BCAC Group A CAH2 Report

June 28, 2024

BCAC will be proposing the following comments.

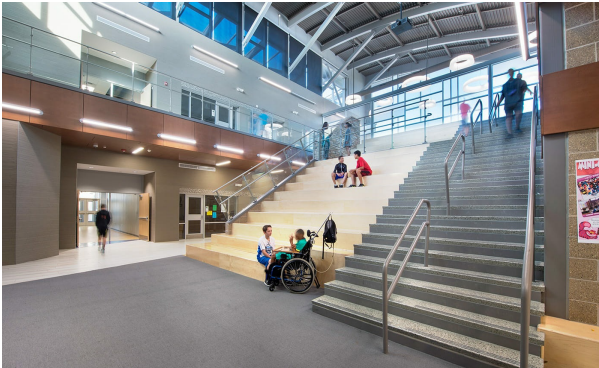
Reason: E106-18 added criteria to 1030.16 to address social stairways.

The question at this point is where there is this type assembly seating immediately adjacent to the egress from the upper floor – how should the capacity of the combined stairway/stepped aisle be calculated? We feel that the proposed language would clarify this issue.

“Where stepped aisles have seating on one side and the aisle width is 74 inches (1880 mm) or greater, two handrails are required.

Where two handrails are required, one of the handrails shall be within 30 inches (762 mm) horizontally of the stepped aisle.”

1006.2.2.5 Vehicular ramps. Vehicular ramps intended only for vehicle traffic shall not be considered as an *exit access ramp* except where a demarcated walkway used exclusively ~~as a~~ for pedestrian traffic ~~way~~ is provided.

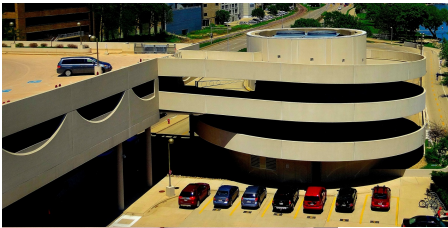
Reason: The modifications are intended to address the committee's concerns.

The requirement for the walkway to be **demarcated** is added to clarify the need for separation but leaves the method of such separation open (barriers, marking, sidewalks, curbs, etc.). The term demarcated is already used in 1016.2 (item 6, exception 2).

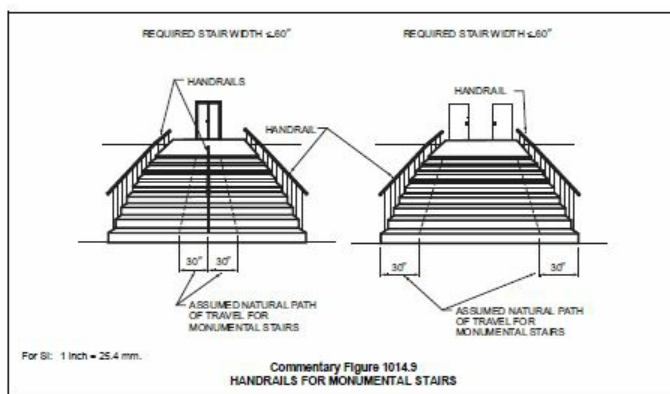
Reason: We believe this proposal was disapproved based on incorrect testimony. Examples were given stating a center handrail was not required until 69", but that is assuming handrail projections. Other proponents thought a center handrail was required on a 44 inch wide stairway. This misunderstanding is why this change is needed.

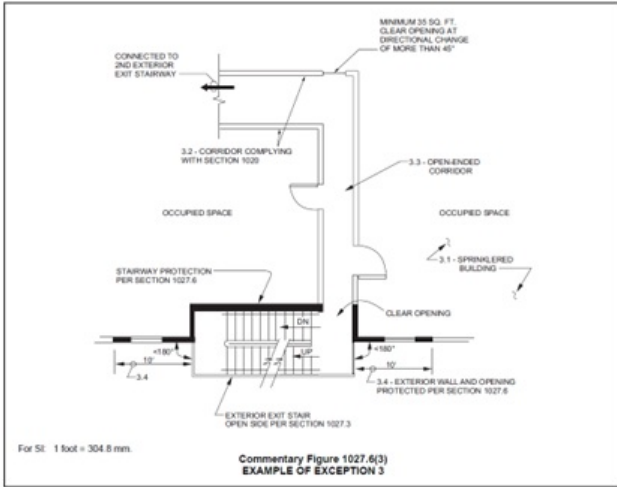
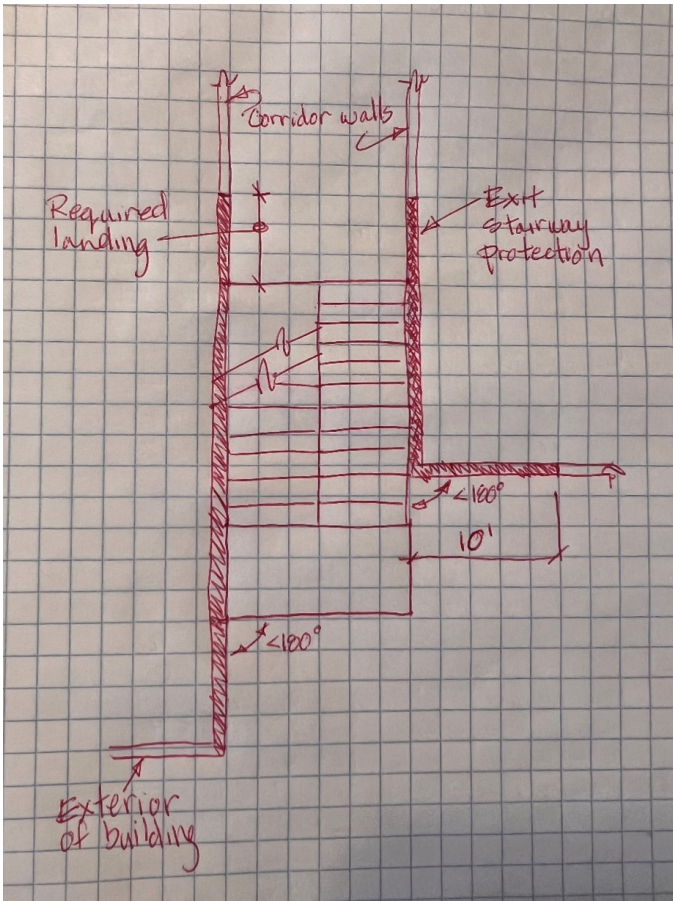
There has been a misinterpretation that the walls on the open-ended corridor are exterior walls in accordance with Item 3.4 instead of the corridor in accordance with 3.2. This can lead to unnecessary ratings on the corridor walls. The added sentence in 3.3 clarifies this. The sentence added in the base paragraph is to address a situation where the exterior exit stairway is completely recessed into the building. It is not clear if the walls between the exterior exit stairway and the exterior of the building is an exterior wall. However, BCAC felt the stairway does need to be available for people to leave the building, so the protection needs to be available. The following is an existing figure in IBC Commentary.

The illustration below gives an orientation of a rotated stair that is partially within the building, illustrating where the rating would stop at the extent of the landing as well as illustrating how the requirement for the ten foot of exterior wall is required to be rated when less than 180 degrees.

CAH1 Committee Reason: There should be a limit to the distance for the the exterior wall length when the building is recessed. It needs to be more specific on the extent of the wall protection. Suggestion to remove "recessed" and find better wording. (Vote: 12-2)

angle of less than 180 degrees (3.14 rad), the *exterior wall* shall be rated in accordance with Section 1023.7. Where the exterior exit stairway is recessed into the building, the separation for the exterior exit stairway or ramp shall extend to the exterior walls.

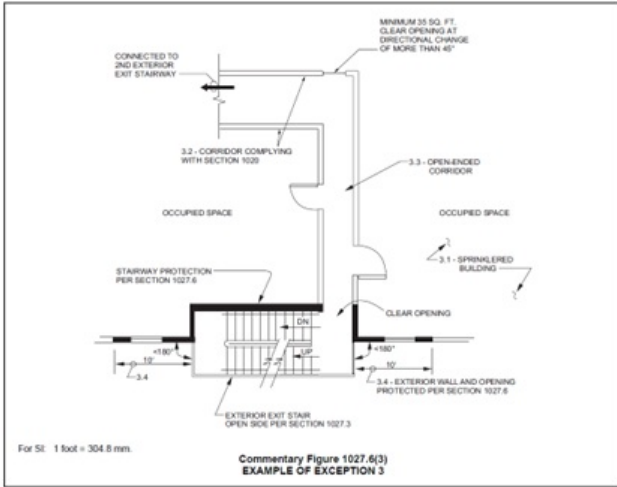
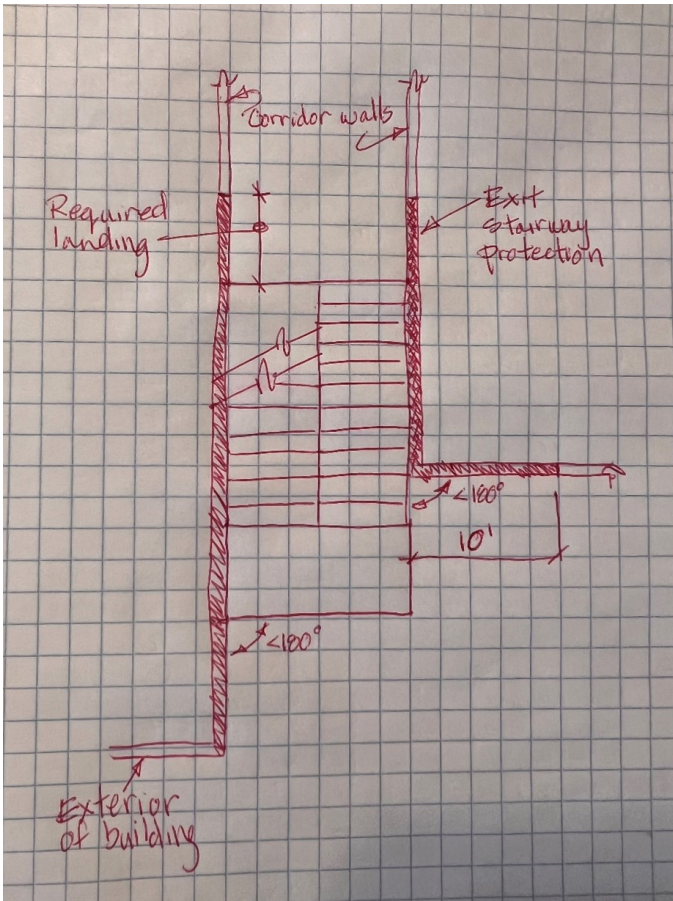
There has been a misinterpretation that the walls on the open-ended corridor are exterior walls in accordance with Item 3.4 instead of the corridor in accordance with 3.2. This can lead to unnecessary ratings on the corridor walls. The added sentence in 3.3 clarifies this. The sentence added in the base paragraph is to address a situation where the exterior exit stairway is completely recessed into the building. It is not clear if the walls between the exterior exit stairway and the exterior of the building is an exterior wall. However, BCAC felt the stairway does need to be available for people to leave the building, so the protection needs to be available. The following is an existing figure in IBC Commentary.

The illustration below gives an orientation of a rotated stair that is partially within the building, illustrating where the rating would stop at the extent of the landing as well as illustrating how the requirement for the ten foot of exterior wall is required to be rated when less than 180 degrees.

angle of less than 180 degrees (3.14 rad), the *exterior wall* shall be rated in accordance with Section 1023.7. Where the exterior exit stairway is recessed into the building, the separation for the exterior exit stairway or ramp shall extend to the exterior walls.
